Detailed Site Plan DSP-17035

Phil Matt Shopping Center

STAFF REPORT

SUBJECT: Detailed Site Plan DSP-17035
Phil Matt Shopping Center
Expedited Transit-Oriented Development

SITE PLAN

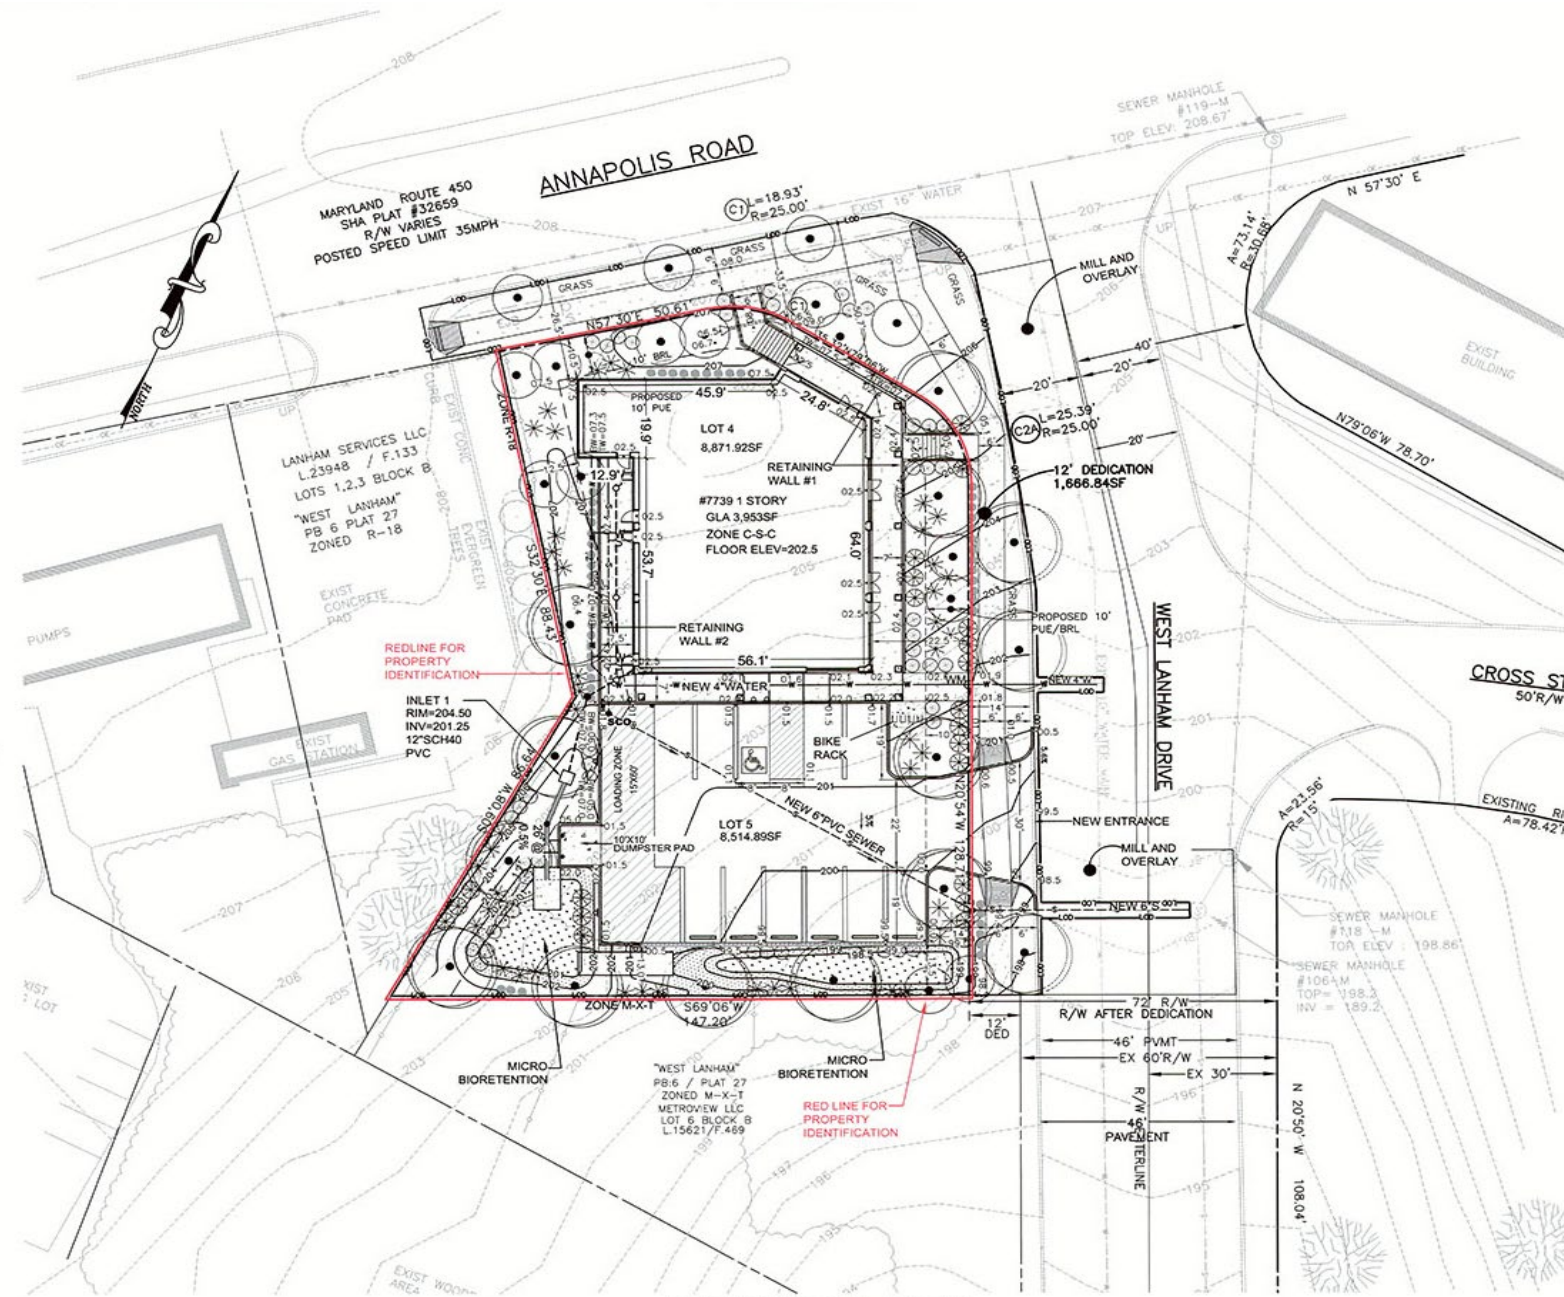
1. Prior to certification of this detailed site plan, the applicant shall:
 - a. Revise the site plan to show and label the modified build-to line, with dimensions and the specific deviation from the required standards.

- b. Show that the area proposed for right-of-way dedication is included within the subject property's boundaries.
 - c. Show all bearings and distances for the existing and proposed lot lines.

- d. Label the 12-foot-wide area which is to be dedicated to public use.
 - e. Provide signage details in conformance with the 2010 *Approved New Carrollton Transit District Development Plan and Transit District Overlay Zoning Map Amendment* standards.

- f. Provide a Tree Canopy Coverage schedule demonstrating conformance to the requirements.
 - g. Provide parking ratios and a reference to the 2010 *Approved New Carrollton Transit District Development Plan and Transit District Overlay Zoning Map Amendment* standard in the parking tabulation on Sheet 6.

SIGNAGE

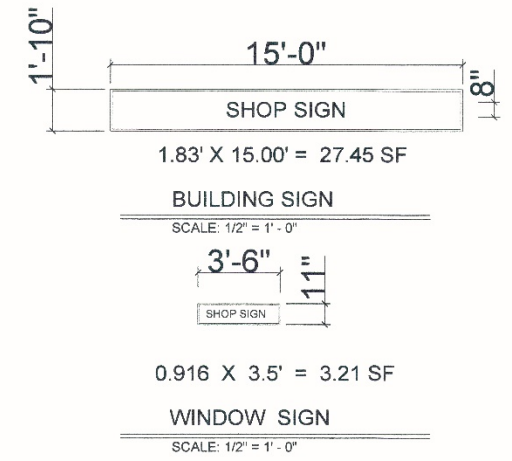
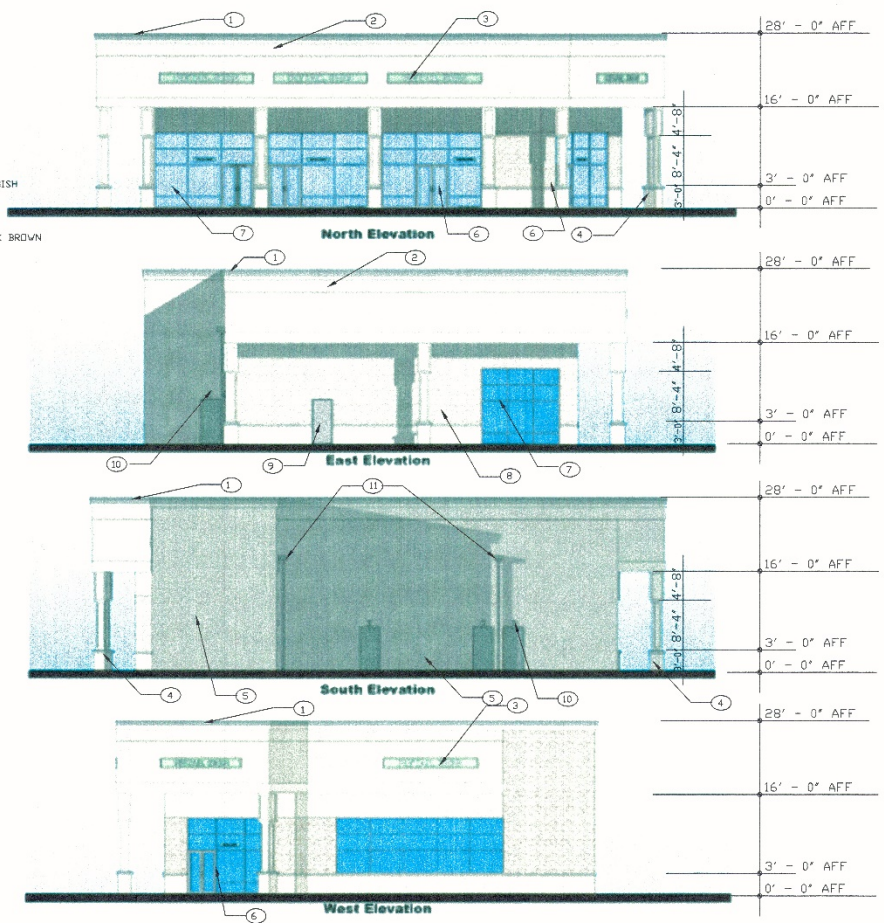
Building-mounted signage will be placed above the store entrances on the top of the arcade. The applicant proposes a maximum of five signs that will be 27.45 square feet each, for a total of 137.25 square feet. The signs will be made of an aluminum base, with raised aluminum lettering, and non-illuminated. The applicant also shows a total of 12.84 square feet of window signage, in four signs of 3.21 square feet each. The signage calculation chart provided refers to Section 27-613 of the Prince George’s County Zoning Ordinance, which does not apply. The applicant is proposing to construct building signs with aluminum material, which conforms to the New Carrollton TDDP/TDOZMA standards, but no other details were provided. Therefore, a condition has been included in the Recommendation section of this report requiring the applicant to provide full details of all signage and demonstrate conformance to the TDDP/TDOZMA standards.
